Response to Submissions and Amendments Report

Concept SSDA (SSD-93222706) and Rezoning Proposal for
Waterloo Estate (South)

Prepared for Stockland and NSW Land and Housing Corporation

Figure 7 Concept Envelope for Building 8BB1 as submitted (left) and as revised (right)

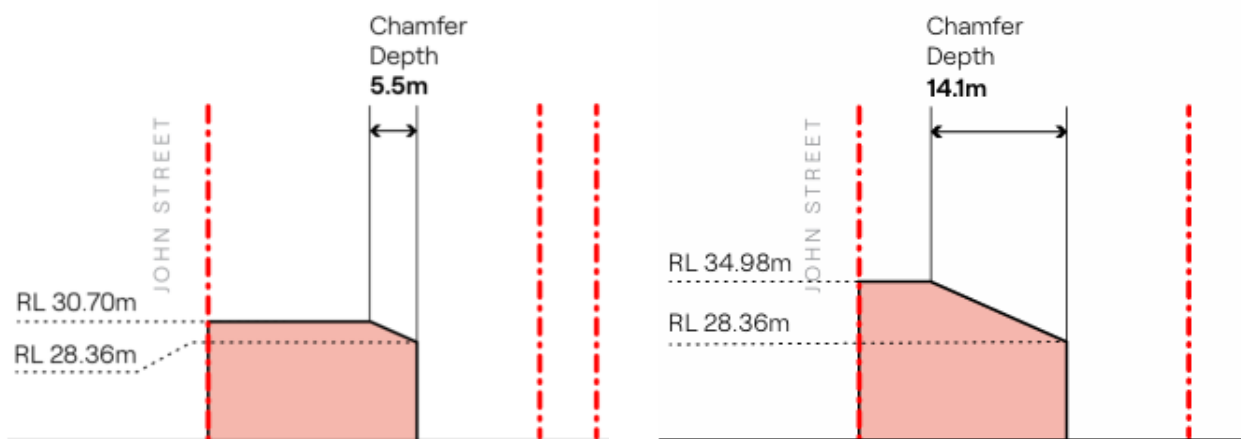
The more substantial increase in the maximum height of the podium component of Building 8BB1 is also considered acceptable, as the chamfered edge of the podium continues to protect the solar amenity of the Block 8 park. **Figure 7** provides a side-by-side comparison of the chamfered edge to the south of Building 8BB1 as submitted with the Concept SSDA and as proposed to be amended as part of this submission. The proposed amendments to the Concept Envelope Plans are intended to provide sufficient flexibility for the detailed design and do not seek to increase the overall yield nor materially change the key built form parameters that informed environmental testing. As such, the conclusions of the previous testing remain applicable to the amended Concept Envelopes.

- Increase the maximum RL of the 6-storey component by 4.28m to allow rooftop plant to be accommodated within the building envelope.
- Building 8CB1
 - Extend the western edge of the podium by 3m to the future lot boundary shared with Cooper Place (the new internal road network around the Block 8 park)

Figure 8 Diagrammatic explanation of planning envelopes

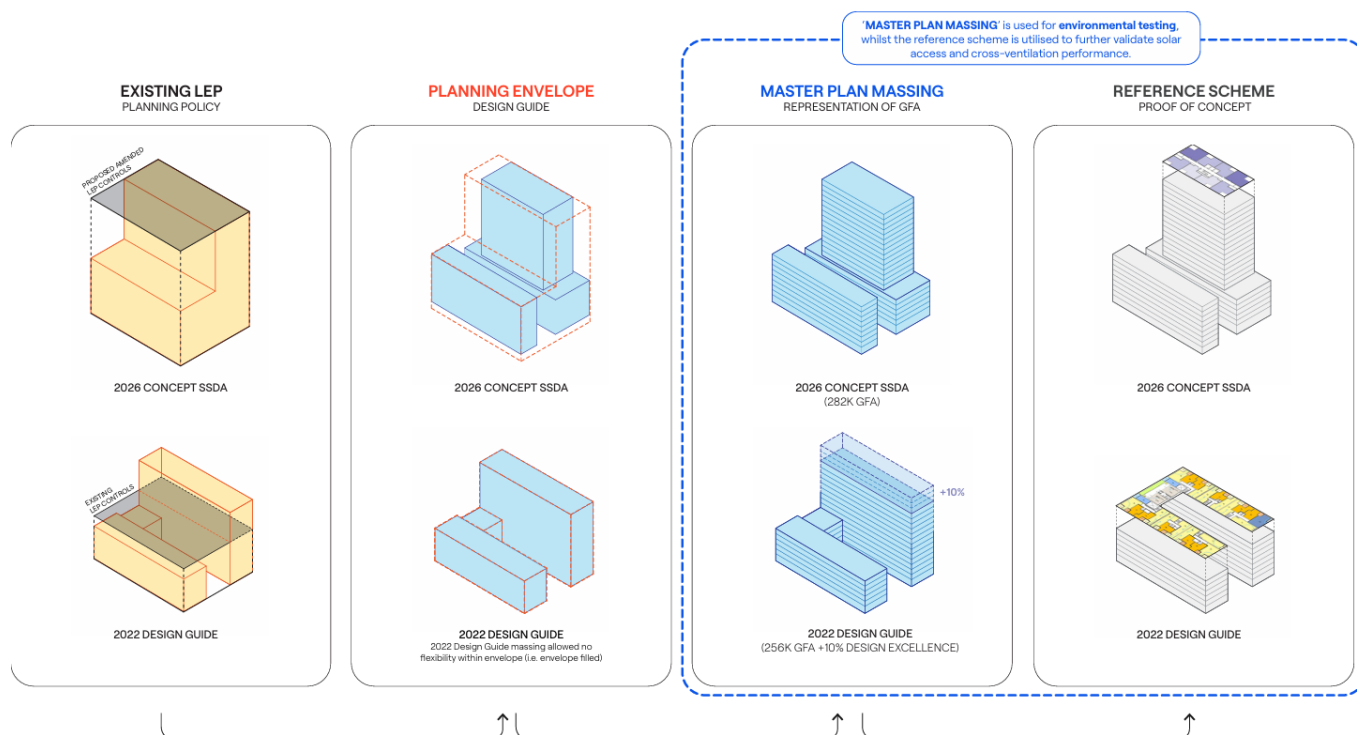
Submissions queried the representation of the proposed built form and yield across the applications noting difficulty in considering the change in impacts of the proposal. In order to clarify the relationship between the planning controls, the built form used for environmental testing and the reference scheme, SJB have prepared the diagram at **Figure 8**.

Figure 9 Proposed Planning Envelopes (shown outlined in red) and Proposed Master Plan massing (shown as grey blocks)

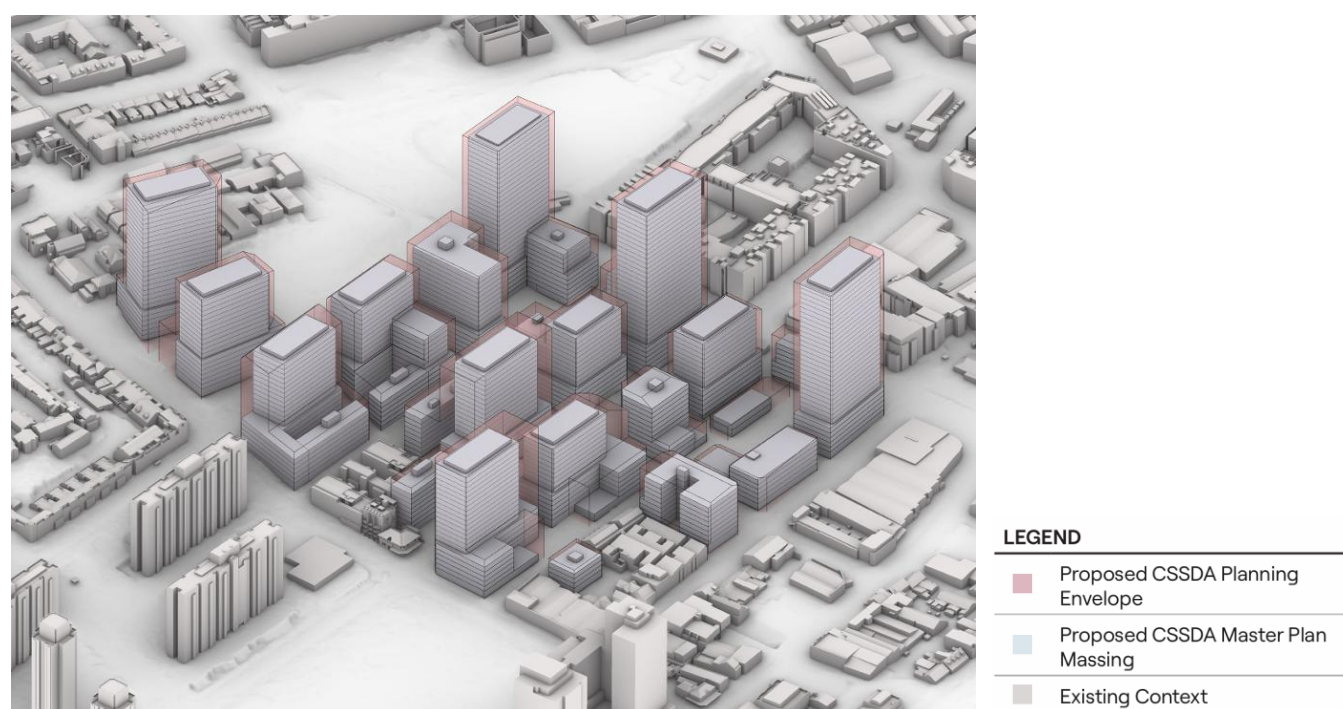
The Master Plan massing is similar to the Planning Envelopes but is reduced to reflect the proposed GFA that is permissible on each block in order to represent a realistic built form that would be permissible within the maximum Planning Envelopes (refer to **Figure 9**). The Master Plan massing is therefore a more suitable baseline to conduct environmental impact assessments such as overshadowing, wind, sky view analysis and visual impacts as it reflects a realistic maximum potential-built form.

The Master Plan massing is representative of the worst-case scenario for environmental assessment purposes considering the total GFA. This is further discussed in **Section 4.1.2**.

Figure 11 Blocks 5 & 6 - Proposed Concept SSDA Envelope (left image) and Revised Design Guide Height in Storeys Map (right image)

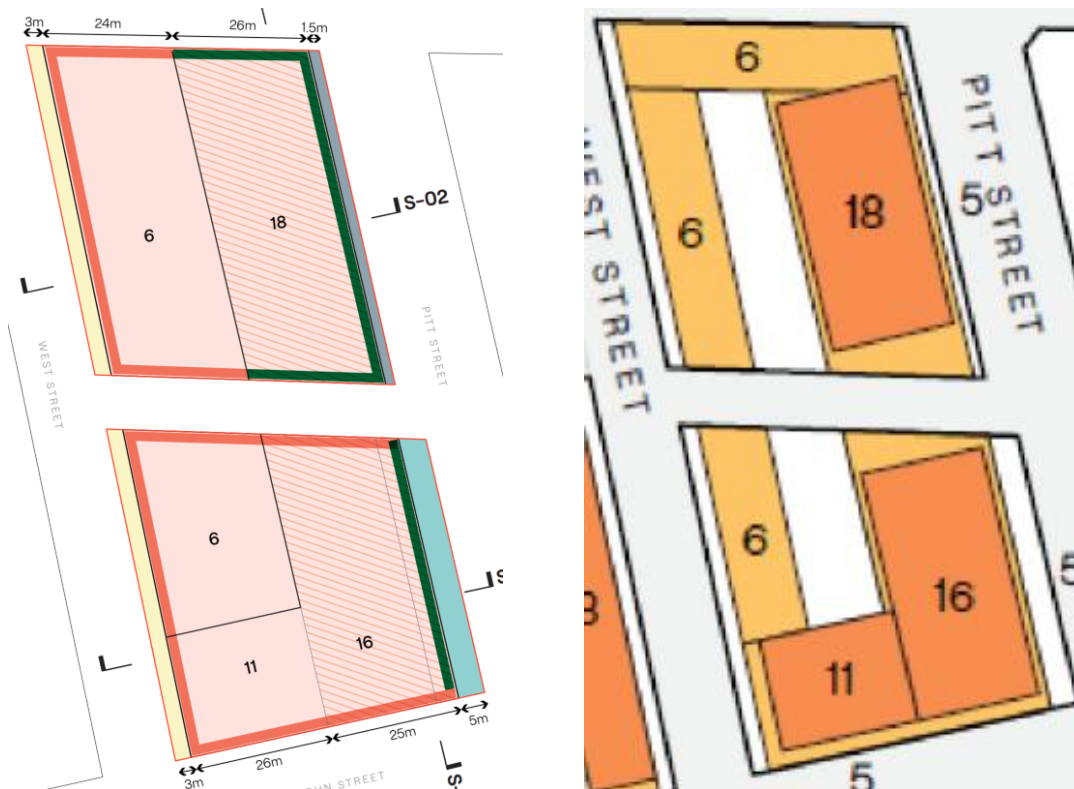
The proposed targeted refinements relating to Blocks 5 and 6 are illustrated in **Figure 10** and **Figure 11**. For these Blocks, the proposed LEP HOB Map has been amended to more closely align to the proposed Concept SSDA Envelopes and Revised Waterloo South Design Guide 2026 'Height in Storeys' controls.

Figure 13 Block 2 - Overshadowing analysis

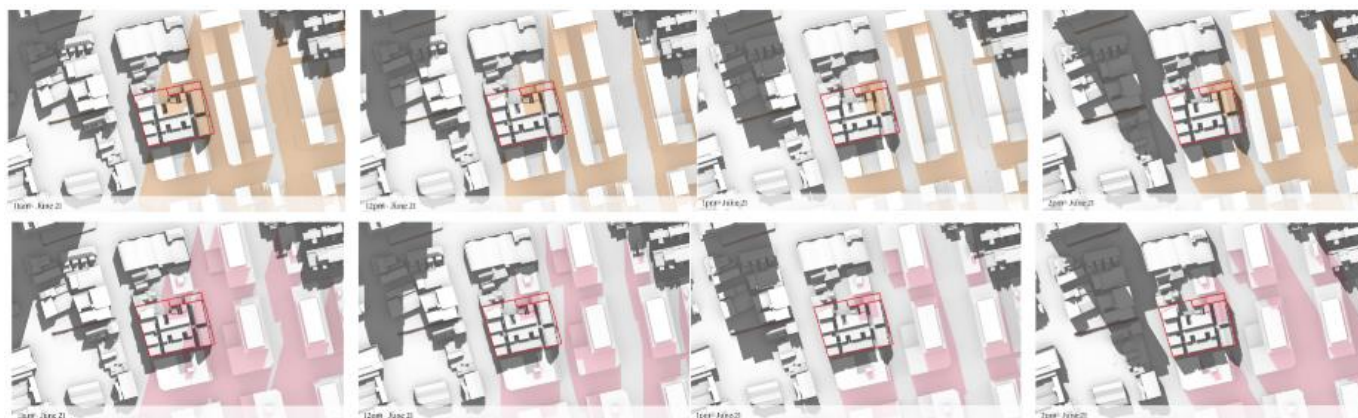
The additional analysis compares the proposed Master Plan massing with the applicable base scenario, comprising the 2022 Design Guide with a 10% increase to FSR to account for the uptake of the design excellence bonus. This provides an appropriate and equitable comparison in respect of total GFA which equates to building massing. Particular attention has been given to Block 2, which contains a number of privately owned properties, including 233-246 Cope Street and 111, 123 and 127 Cooper Street.

The analysis demonstrates that while these properties within Block 2 would experience some overshadowing under the proposed Master Plan massing, they would generally remain free from shadow between 11:00am and 2:00pm in mid-winter before becoming affected by shadows from the Waterloo Metro Quarter development (refer to **Figure 13**). The exception is 111-113 Cooper Street which experiences overshadowing during this window from the proposed Block 2B community building. Notably, this overshadowing exists under both the 2022 Design Guide (+10%) and Master Plan massing scenarios and is therefore not the result of the Rezoning Proposal or Concept SSDA, but is an expected condition under the current planning framework.

Figure 15 Precinct Solar Analysis - Master plan massing scenario (including proposed 1.5m upper level setbacks on George Street)

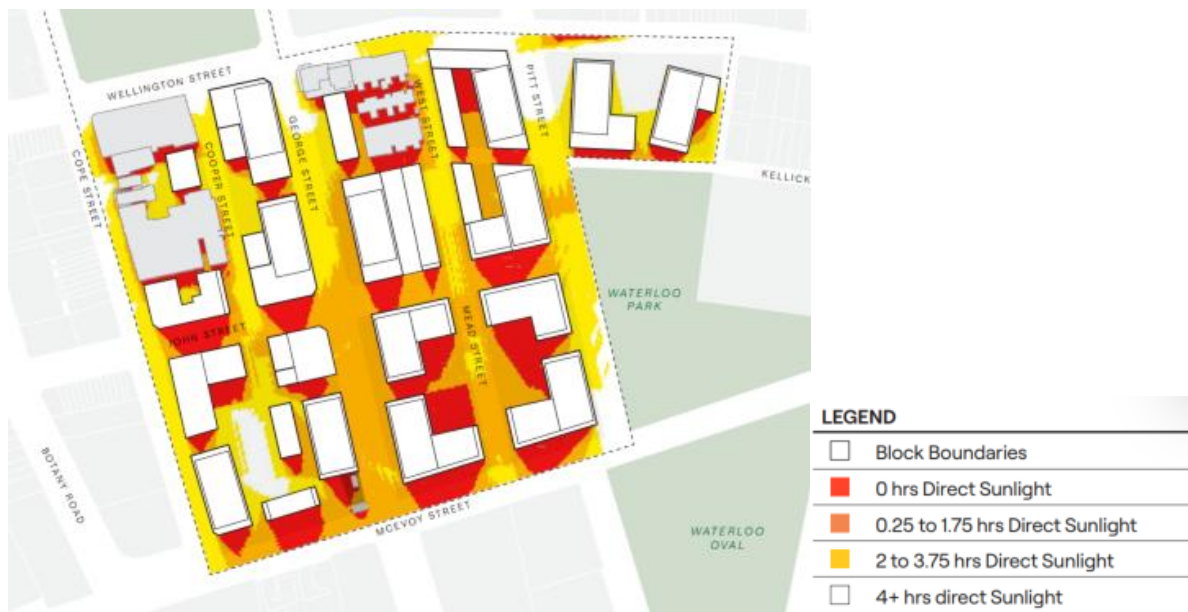
As detailed within **Section 4.3.1.2** the proposed massing continues to ensure amenity is shared by public domain across the precinct. Where there are reductions in solar access to some locations, for example to George Street, increases are proposed to other locations, for example to Cooper Place (refer to **Figure 14** and **Figure 15**).

Figure 16 Block 7 - Comparison of 2022 Design Guide (+10%) (left images) and proposed master plan massing (right images)

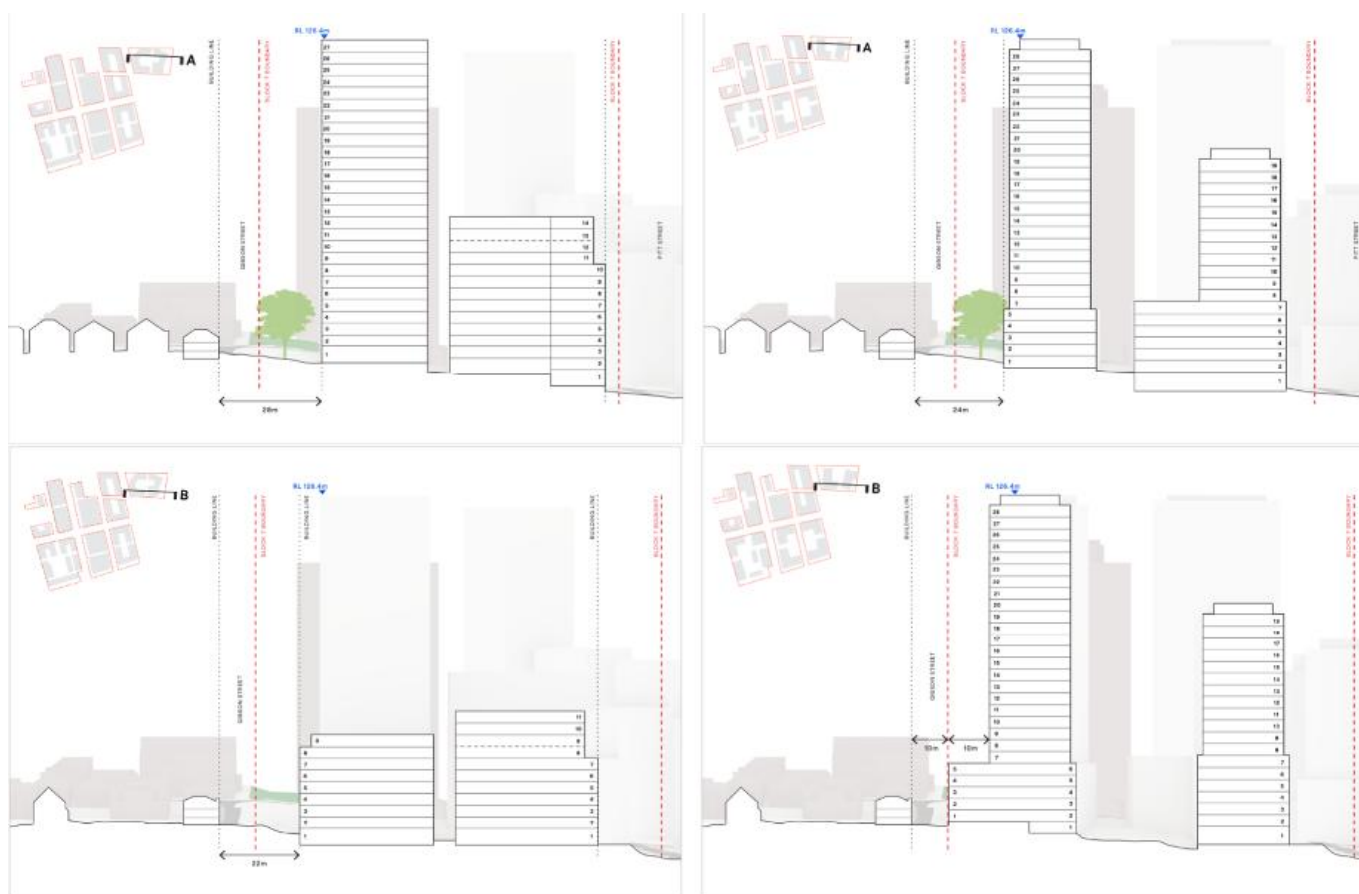
Despite this, the stepped built form is maintained and a generous 9m tower-level setback is embedded into the Concept SSDA Envelopes to ensure the stepped transition between lower density development to the east on Gibson Street and the tower-built form of Building 7A is maintained. It is also reinforced that the proposal does not seek to amend the existing development standard that establishes a maximum building height of RL 126.40m.

The stepped interface is further reinforced by the maximum street wall height control established by the revised Design Guide. The maximum 5-storey street wall height along the eastern interface of Block 7 represents an improvement to the ground plane by presenting a more human-scaled development compared to the 2022 Design Guide. Similarly, to ensure the development remains at the pedestrian scale to the north, a maximum street wall height of 6 and 7 storeys is along the Wellington Street frontage of Block 7. **Figure 16** provides a side-by-side comparison of development contemplated by the 2022 Design Guide and the proposed Master Plan.

Figure 18 Block 2 - Proposed Concept Envelope Section 02

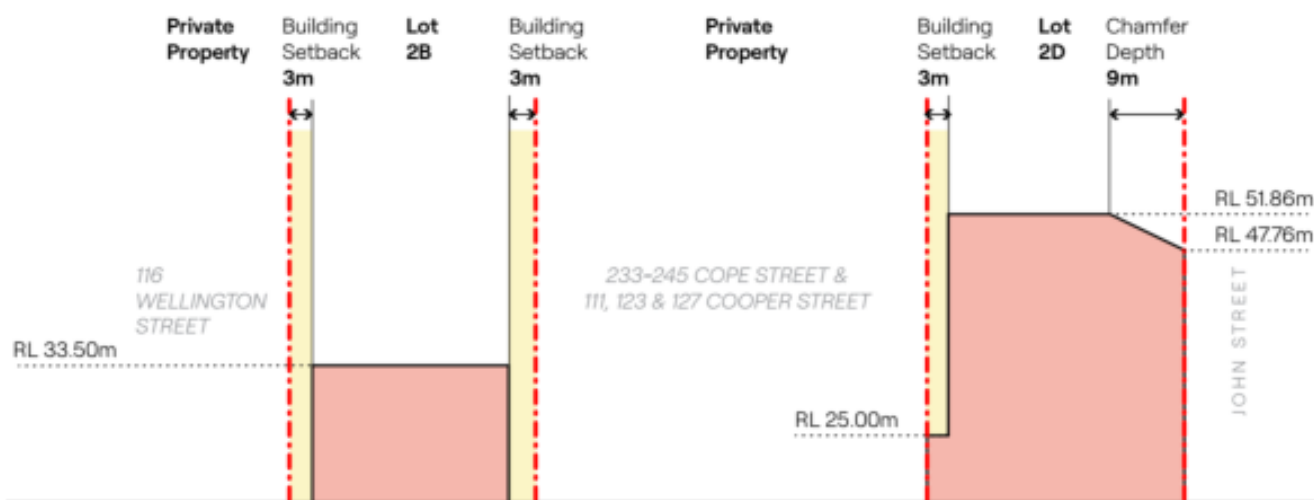
No ground level setback is proposed to account for a future vehicular access to the privately owned properties within Block 2 should they redevelop in the future (refer to **Figure 17** and **Figure 18**). The upper-level setbacks proposed by the Concept SSDA Envelopes are consistent with the 2022 Design Guide as depicted within the revised Design Guide (refer to **Appendix D**).

Figure 23 Overshadowing Study of Yu Ming Temple

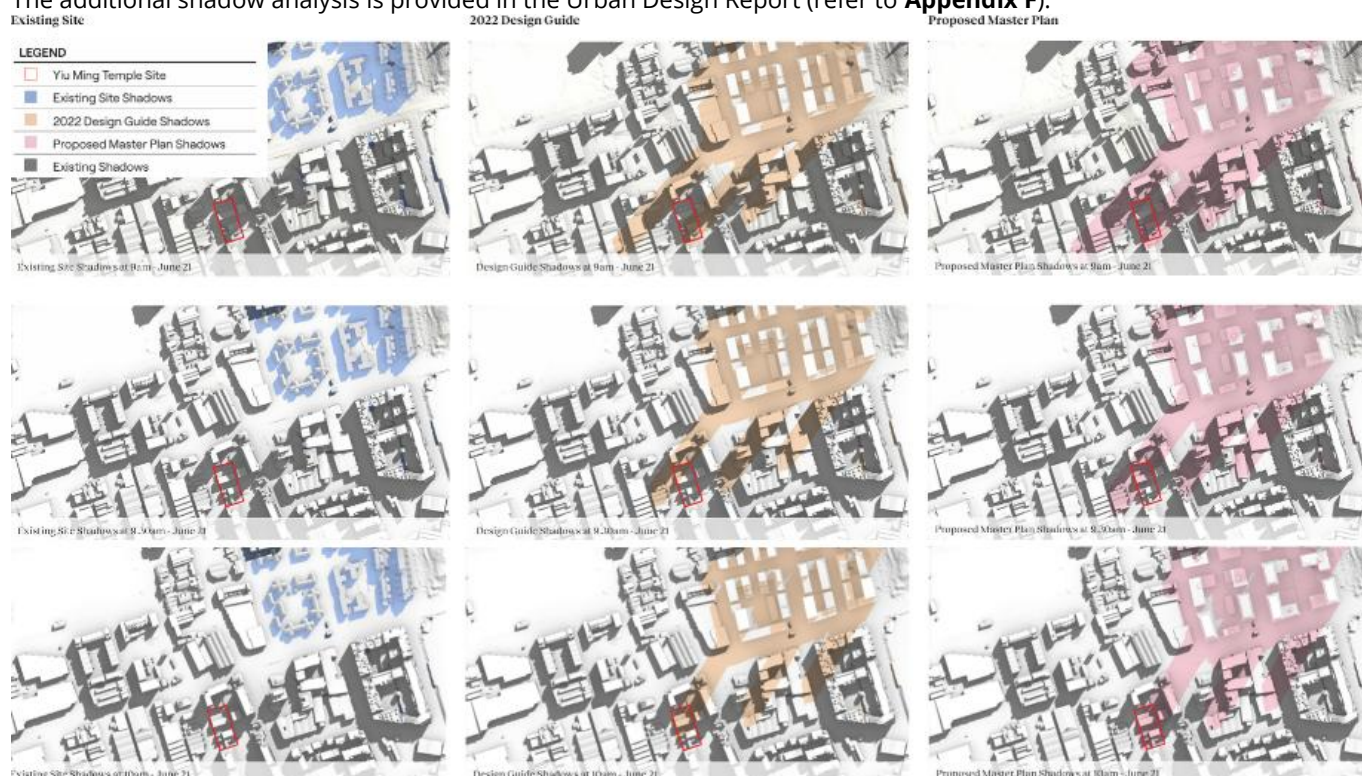
The extent of overshadowing resulting from the proposed Master Plan is broadly comparable to that generated by the 2022 Design Guide envelope. From approximately 10:30am onwards, the Yiu Ming Temple site is not affected by shadows cast by the proposed Master Plan massing (refer to **Figure 23**). The Addendum Statement of Heritage Impact (refer to **Appendix P**) confirms that the minor increase to overshadowing as a result of the proposal would not impact upon the heritage significance of the item.

Figure 25 Revised Figure 19 Stormwater

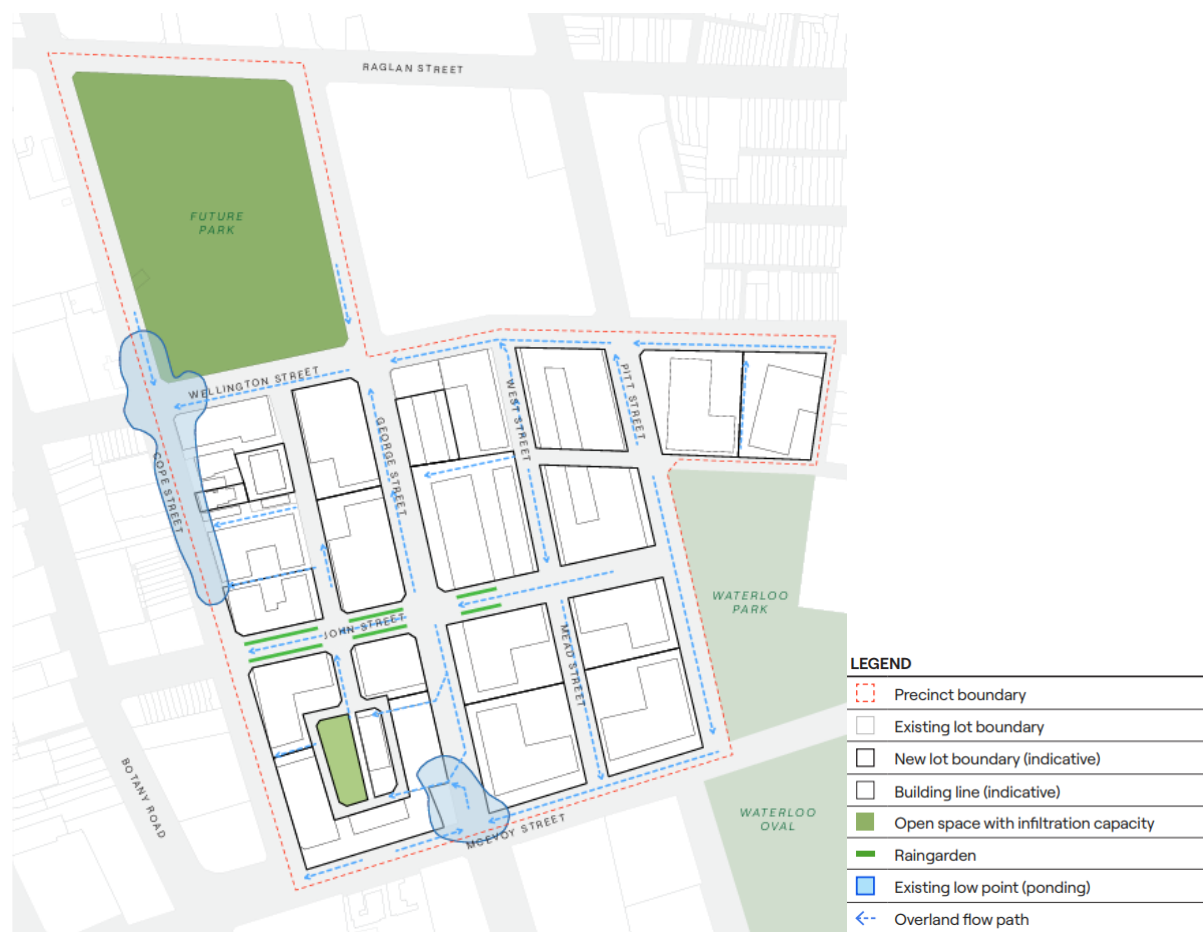
The design of Block 8 has considered the existing overland flow path, as detailed within the Stormwater Management Plan submitted with the Concept SSDA and shown in Figure 22 of the revised Waterloo South Design Guide 2026 (refer to Figure 25).
